**COBB COUNTY
DEPARTMENT OF TRANSPORTATION
ENGINEERING DIVISION**

Cumberland Boulevard Roadway Improvements
Project No. X2604
P.I. No. 0014012
October 10, 2016

ADDENDUM NO. 2

ECHELON PLUS PANEL MAJESTIC 4R EXT 4" GAP 6'H 8'W

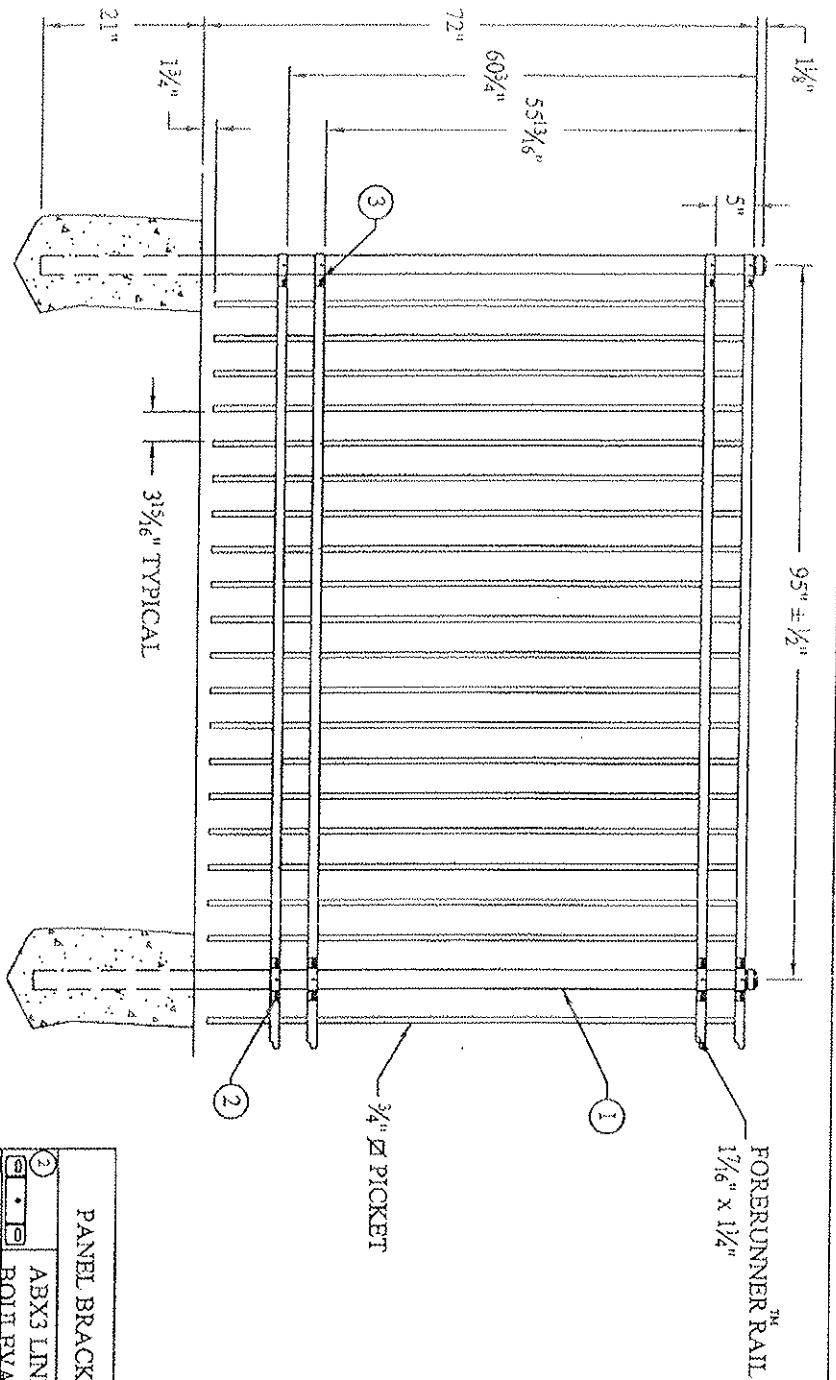
Q. Referring to line item 535(643-8300 ORNAMENTAL FENCE) in bid schedule, please provide the detail for ornamental fence.

A. **Please see attached, height is four foot.**
